This amendment raises the Crystal River Unit 3 Technical Specification limit on maximum steam generator secondary water level from 360 inches to approximately 380 inches in operating modes 1 through 3 to provide more operating flexibility. This change was justified by supplementary analyses performed on behalf of Florida Power Corporation and submitted to the Commission.

CRYSTAL RIVER UNIT 3 NUCLEAR GENERATING PLANT

Amendment No. 68
License No. DPR-72

SAFETY EVALUATION BY THE OFFICE OF NUCLEAR REACTOR REGULATION
SUPPORTING AMENDMENT NO. 68 TO FACILITY OPERATING LICENSE NO. DPR-72
FLORIDA POWER CORPORATION, ET AL.
CRYSTAL RIVER UNIT NO. 3 NUCLEAR GENERATING PLANT
DOCKET NO. 50-302

FIGURE 3.4-5

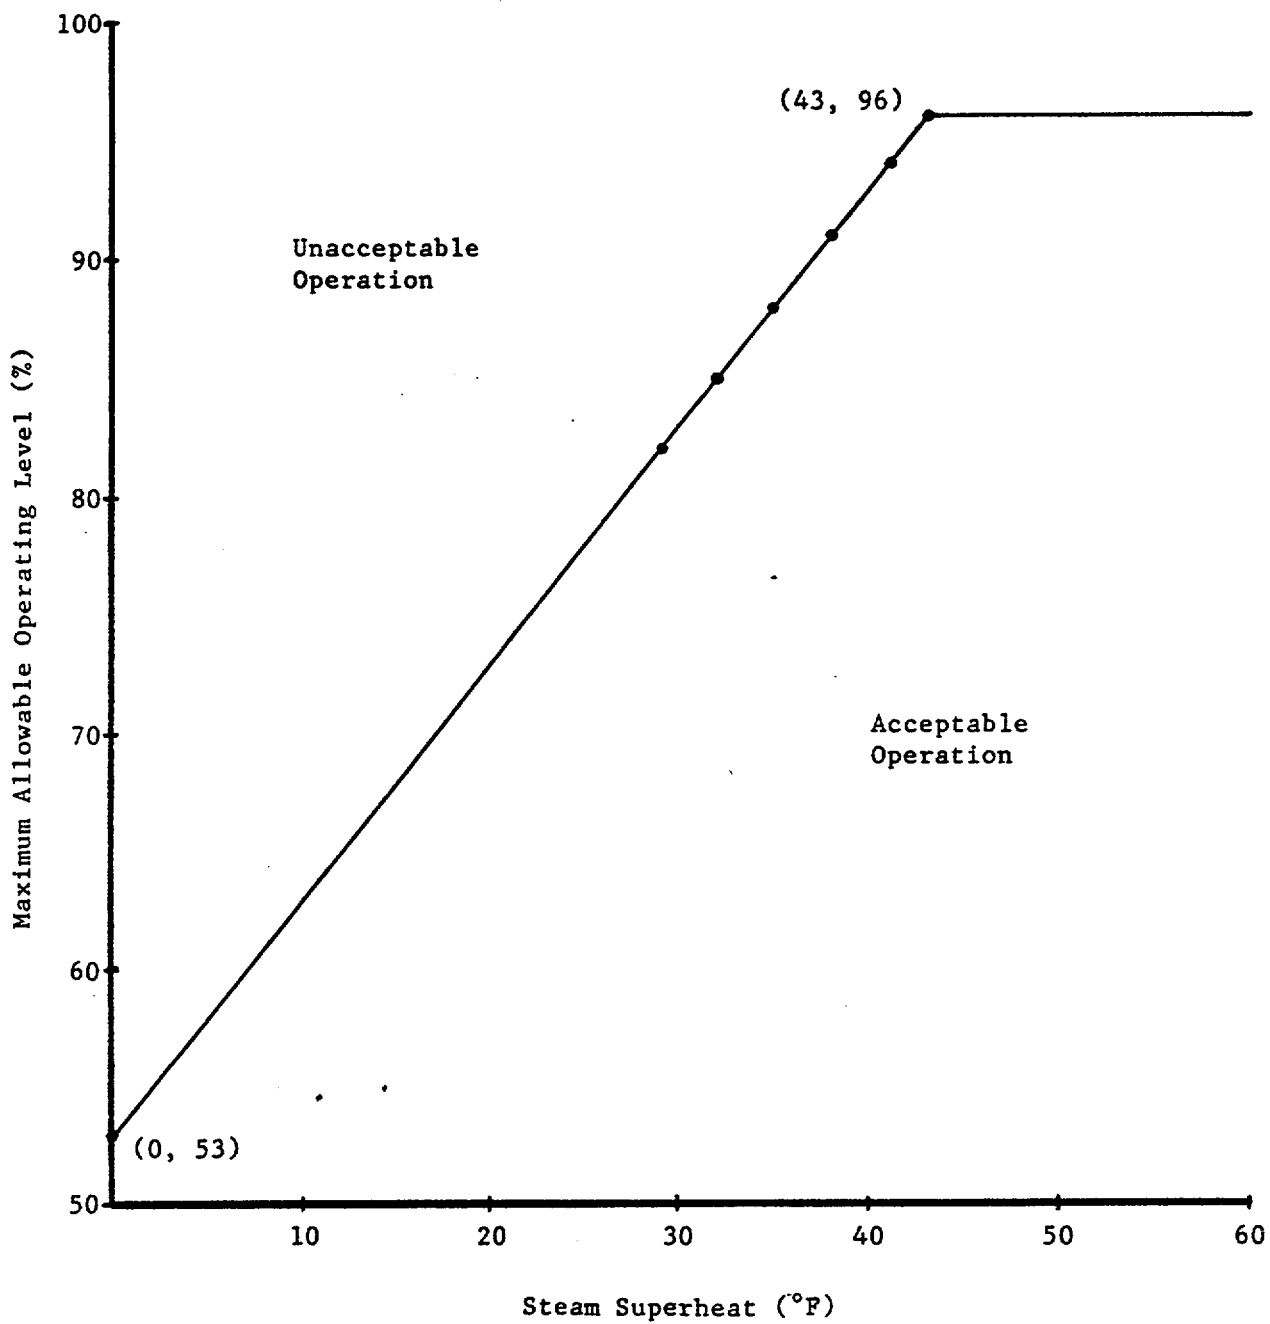
3.4.5 Each steam generator shall be OPERABLE with a maximum water level as specified on Figure 3.4-5 and a minimum water level of 18 inches.

*As noted on Figure 3.4-5, maximum water level restrictions are not applicable in MODE 4.

The current Technical Specification limit for downcomer water level is 360 inches which corresponds to about 87% on the operating range scale. The licensee requests that the limit be raised to 96% on the operating range which corresponds to approximately 382 inches of downcomer level above the lower tube sheet. The aspirator ports within the steam generator shroud which provide for feedwater heating are located at 386 inches. The original limit was based on a conservative calculation of level at the maximum steam generator inventory assumed in the Final Safety Analysis Report (FSAR) of 62,600 lbm. This is the steam generator inventory assumed for the main steam line break calculation of reactor overcooling, environmental doses and containment pressure. The licensee submitted a new calculation of steam generator inventory which concludes the inventory will be less than 57,000 lbm even at the new level limit. This result was confirmed by the staff using the RELAP5 computer code.

The licensee also requests that the TSs be revised to remove steam generator level requirements for Mode 4 operation (hot shutdown). Currently the steam generators are allowed to be filled only at cold shutdown. The change would allow filling of the OTSGs at temperatures up to 280°F. The consequences of a main steam line rupture at this temperature would be less than that of the FSAR case at full power. The staff concludes the licensee's proposed change removing level restrictions for Mode 4 operation is acceptable.

MAXIMUM ALLOWABLE STEAM GENERATOR LEVEL*

*Not applicable to Mode 4 operation.
